# TECHNICAL INFORMATION

59228

- Subject** ▶ Change of Spur Gear 53
- For Models** ▶ 5621RDW
- Country** ▶ All countries
- Description** ▶ Spur Gear 53 has been modified as illustrated below.

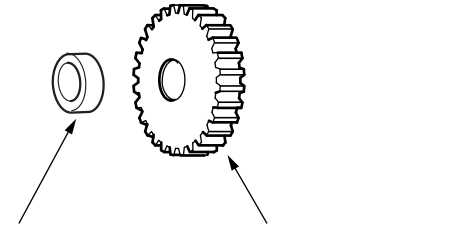
▶ Current	▶ New
 <p>Ring 12 (Part No.257010-0)</p> <p>Spur Gear 53 (Part No.226370-1)</p>	<p>1) Spur Gear 53 has been modified. 2) Ring 12 has been eliminated.</p>  <p>Spur Gear 53 (Part No.226391-3)</p>

Item No.	Current part		Q'ty	I/C	New part		Q'ty	Note
055	Spur Gear 53 226370-1		1	No	Spur Gear 53 226391-3		1	Interchangeable as a set
053	Ring 12 257010-0		1

From serial No.4965E (Sep.,1999)
